# Access Compliance Report

## Public Rights-of-Way

Intersection ID: 30227	Main Street: CLARA_DUNN_LN	Cross Street: PATRICIA_RYAN_DR	Location:	N
ADA ID: 9F4A8FA24CB1	Ramp Type: PerpDiag	Initial Pass/Fail: Fail	Overall Compliance: No	Severity Score: 8.75
Codes/Mitigation Info/Possible Solution		Field Measurements/Component Compliance

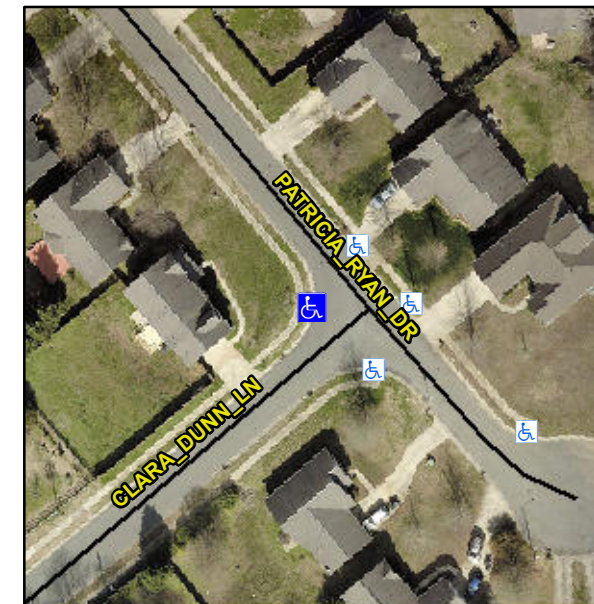
**Not Found, R304.5.1**

Compliance	Description	Data	Compliance	Description	Data
N/A	Ramp Length (in)	48.0	Yes	Ramp Slope (%)	8.1
No	Ramp Width (in)	42.5	Yes	Ramp XSlope (%)	2.0
N/A	Flare Type LT	N/A	N/A	Flare Type RT	N/A
N/A	Flare Slope LT (%)	N/A	N/A	Flare Slope RT (%)	N/A
N/A	Flare Traversable LT?	N/A	N/A	Flare Traversable RT?	N/A
N/A	Landing Length (in)	N/A	N/A	DWS Provided?	N/A
N/A	Landing Width (in)	N/A	N/A	DWS Contrast?	N/A
N/A	Landing Slope (%)	N/A	N/A	DWS Length (in)	N/A
N/A	Landing X Slope (%)	N/A	N/A	DWS Full Width?	N/A
N/A	Landing Curb? (Y/N)	N/A	N/A	DWS Offset (in)	N/A
N/A	Shared Landing?	N/A			
N/A	Gutter Ponding?	N/A	N/A	Gutter Slope (%)	N/A
N/A	Gutter Lip Ht (in)	N/A	N/A	Gutter X Slope (%)	N/A
N/A	Painted X Walk1?	No	N/A	Painted X Walk2?	No
	X Walk 1 Direction	To SE		X Walk 2 Direction	To E
N/A	X Walk 1 Width (in)	N/A	N/A	X Walk 2 Width (in)	N/A
	X Walk 1 Slope (%)	2.3		X Walk 2 Slope (%)	1.0
	X Walk 1 X Slope (%)	0.2		X Walk 2 X Slope (%)	3.5

**Remove & Replace Curb Ramp With Two New Directional Ramps or Equivalent.**
